### **ADDENDUM No. 3**

**Autryville Stormwater Improvements  
Town of Autryville, NC  
Addendum Date: February 11, 2025**

This Addendum Number THREE provides answers to questions received from Bidders before February 10, 2025.

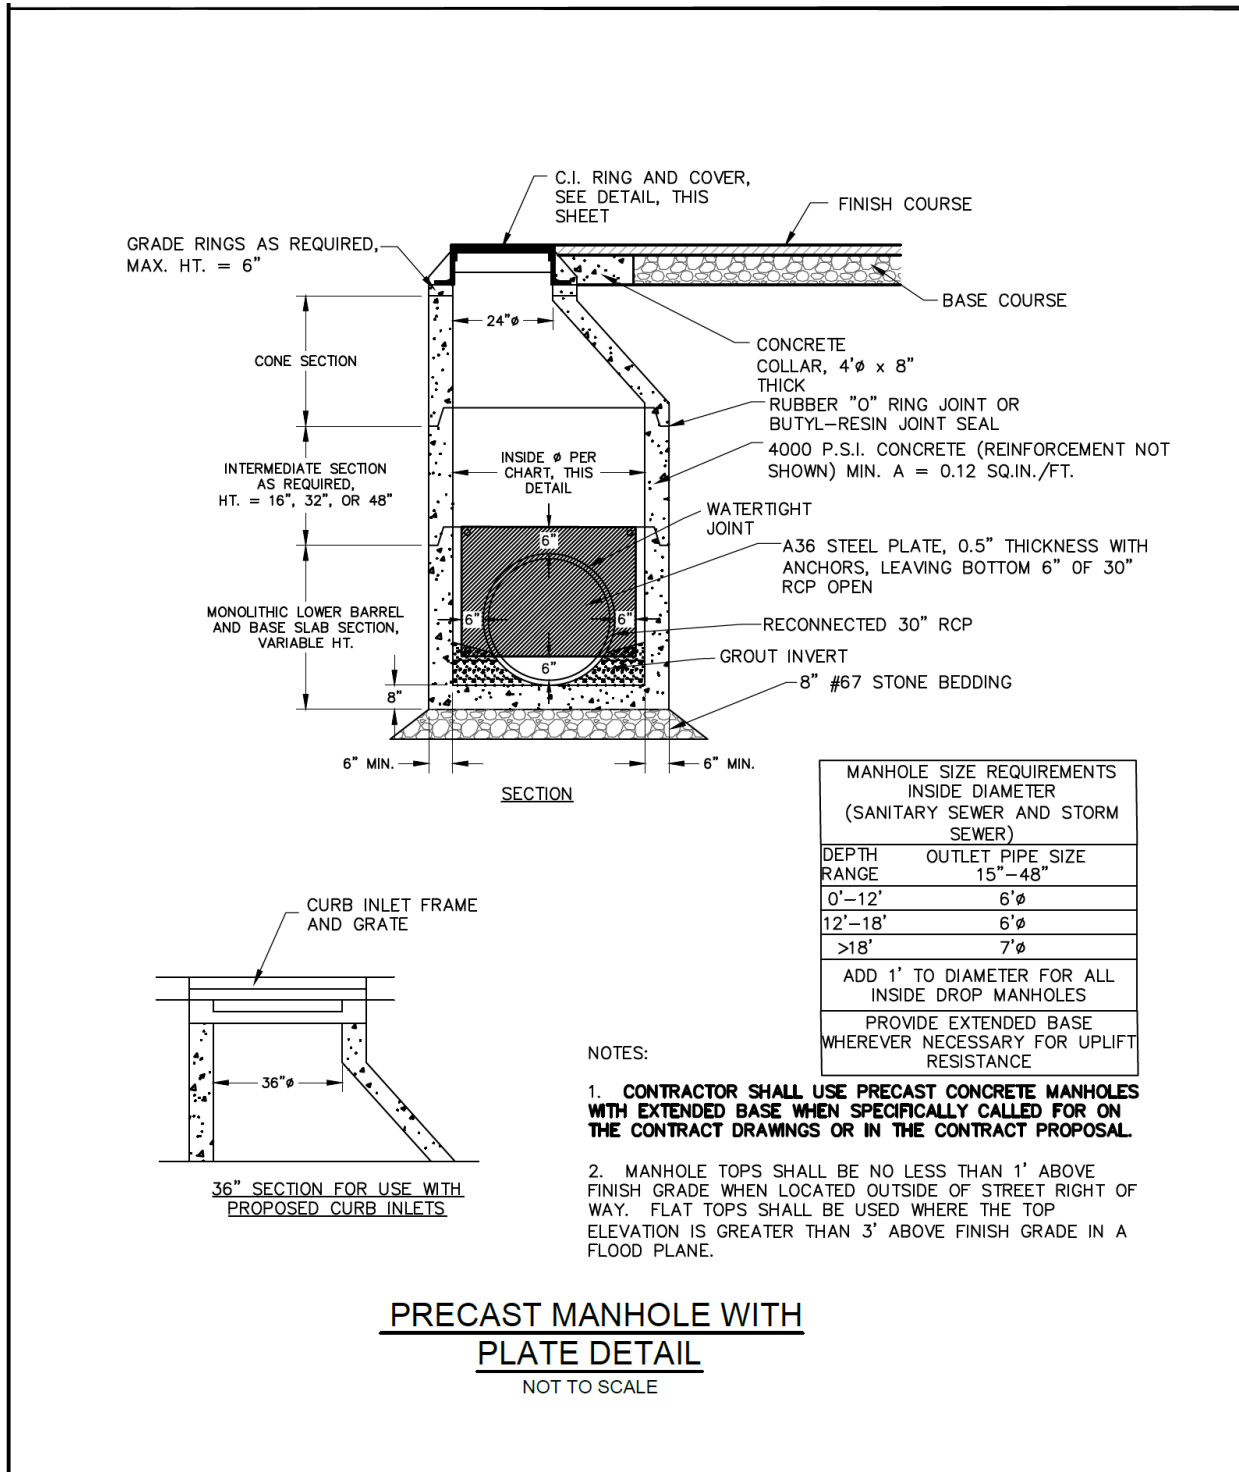
Q4: MH 2 is called out as a 6' diameter manhole with a steel plate installed on the 30" RCP. Will this need to be a curved plate to match the interior dimensions of the manhole, or can this be changed to a square box with a flat plate? What are the requirements for the steel plate (thickness, material type, etc.)?

A4: The Contractor may submit an alternate design for any structure in accordance with the Project Specifications. All alternate designs must meet the latest NCDOT specifications and standards. Please see Details 840.34 Traffic Bearing Junction Box and 840.46 Traffic Bearing Precast Drainage

Structure on Plan Sheet C-51. The steel plate shall be grade A36 steel and the size and thickness shown in the updated Detail below.
